From: Eatch Beck - Capital Projects on behalf of Eatch Beck - Capital Projects <BeckE@ckschools.org>
To: Thiel Sydney - Capital Projects; licensing@ahbl.com; Nick Rheaume
Cc: Johnny Hong; Richard Wilson (rwilson@integrusarch.com); Mike Hager; Craig Skipton
Subject: RE: Soule Drainage Pipe
Date: Monday, January 7, 2019 10:21:24 AM
Attachments: image001.png

Mike and I field reviewed the Soule property to the north of the tennis courts. We observed a 4' drain pipe from the property outletting onto the school district property. It is most likely the roof drainage. This pipe was not identified in the design survey. The survey contours and spot elevations do not pick up the elevation at the low spot in the Soule property back yard near their fence. It is lower than 180.

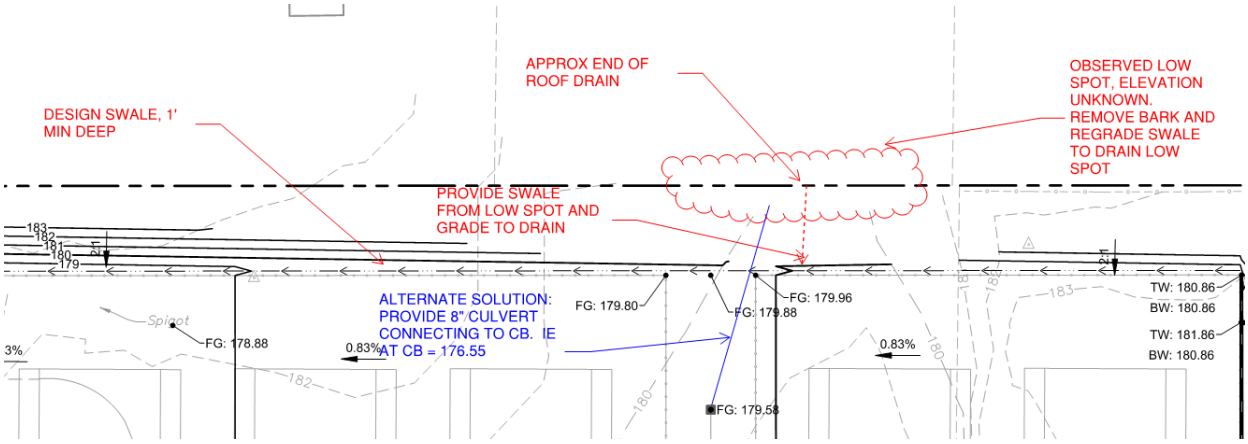
The design intent shown on the drawings is to provide a swale along the north edge of the tennis courts. The V-ditch should be a minimum of 1 foot deep and slope to the west, eventually outletting into the ditch along Frontier. I see two possible solutions:

Option 1. Establish the ditch as shown below in red. Removing bark and regrading is necessary to provide the ditch 1 foot deep and maintain a slope of .83% to the west. The elevation of the low spot should be obtained as well as the outlet end of the roof drain pipe to confirm this depth of swale is adequate.

Option 2. Provide a 8" culvert from the low spot at the north property line and connect to the tennis court CB. Repair HMA paving.

Thank you, Doreen.
My preference is Option 1, simply to avoid rework of finished surface at the tennis court alley.
My current opinion is that the majority of this work is corrective action, rather than a change directive. The possible exception being the small length of regrading from the Soule's outlet pipe to the swale. Do you agree?
